Implications of the Proposed Concept Plan Amendments (MP_0166 MOD5)

ANNEXURE 1 – Ku-ring-gai Council's comments on MP07_0166 MOD 5
Concept Plan - Sydney Adventist Hospital, 185 Fox Valley Road, Wahroonga – PRECINCT B - Central Church

4.0 SUBJECT MODIFICATION PRECINCT B - CENTRAL CHURCH

Figure 1: Precinct D - Fox Valley East

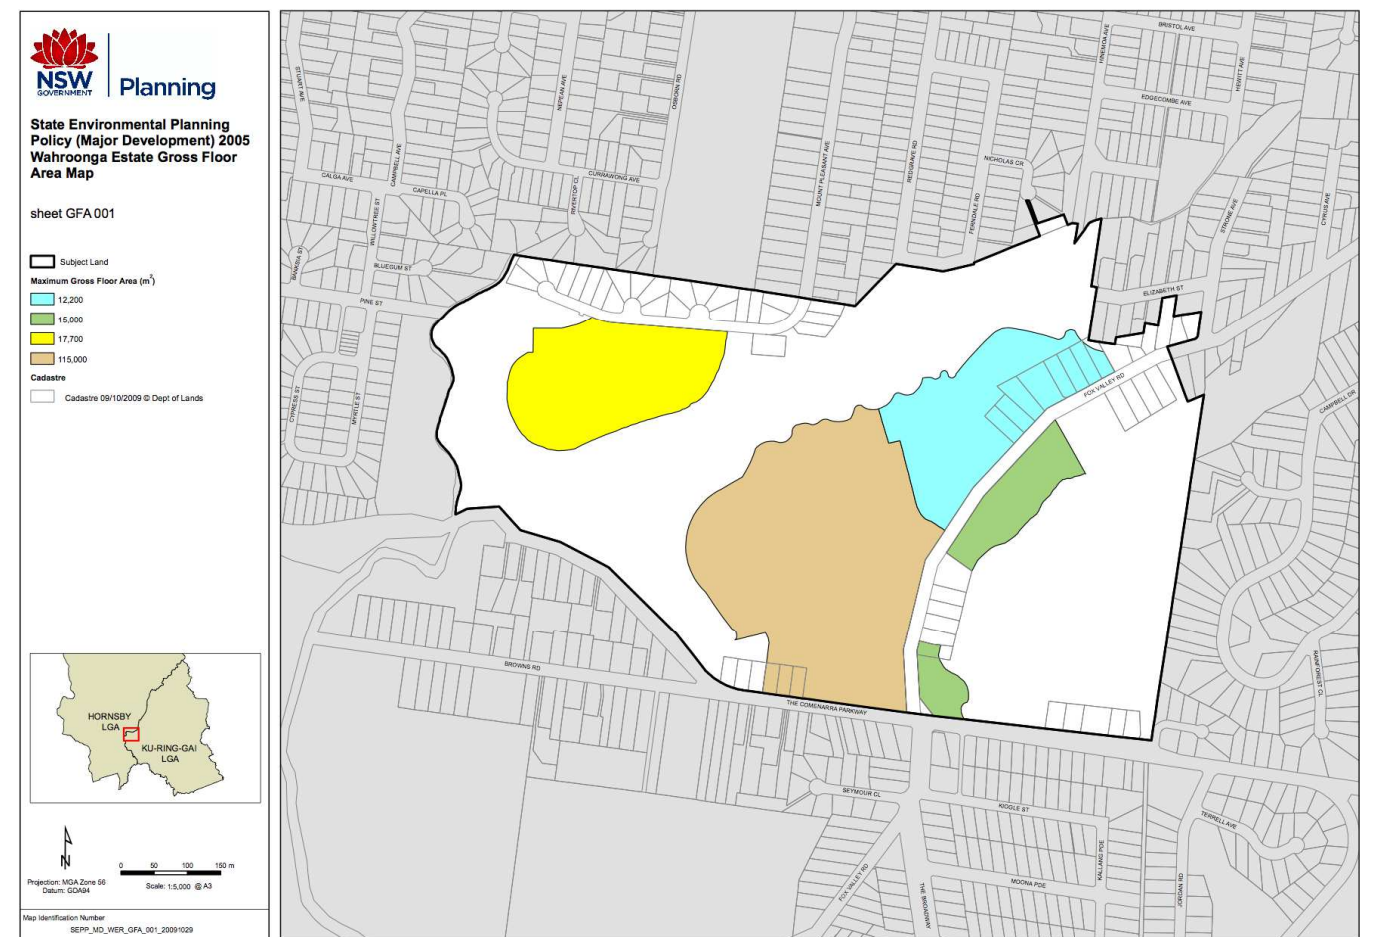
Figure 1 above shows Fox Valley East Precinct as a single entity with a total commercial GFA of 15,000m2. The allocation of this GFA was approved as 8,000m2 existing GFA (with 2,000m2 to augment existing functions) leaving 5,000m2 commercial GFA for the Neighbour Centre commercial building. Refer *Wahroonga Estate Redevelopment Final Preferred Project and Concept Plan 2010*, p51
<https://majorprojects.affinitylive.com/public/9cb9791229df230a0b64623e6beb5429/FINAL%20Preferred%20Project%20Report%20Part%202%20Jan%202010.pdf>

Further inconsistencies within MP07_0166 arise between the landscape areas nominated on the Concept Plan and required vehicular movements. Vehicular access requirements have only partly been accommodated leaving the impression of a green, leafy open landscape being achieved (and claimed in performance criteria). The reality has been quite different with extended and widened access roads, driveways, and increases to at-grade car parking.

Figure 10: The Wahroonga Estate - aerial photo July 2013

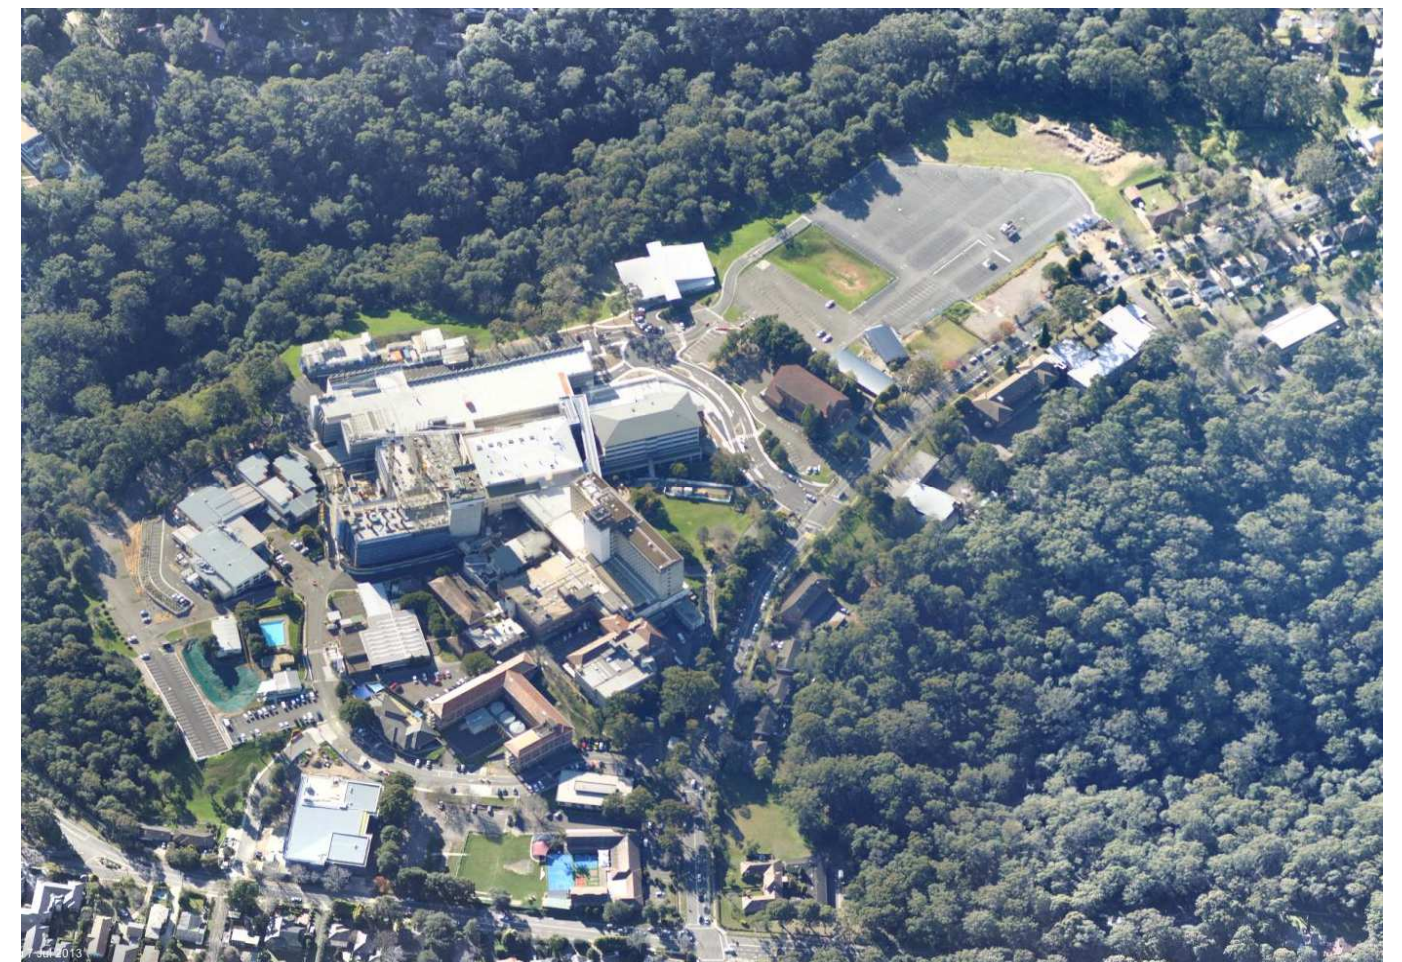
Figures 9 and 10 below demonstrate the change in urban character across the Wahroonga Estate as it is well into its process of transition.

It is clear that provision of the open landscape setting that formed Concept Approval MP07_0166 has been incrementally eroded with the scale of development combined with modifications to building footprints.

Figures 9 and 10 provide clear evidence of the effect upon the urban character when cumulative impacts are not accounted for, and demonstrates the clear pattern of redevelopment across the Wahroonga Estate.
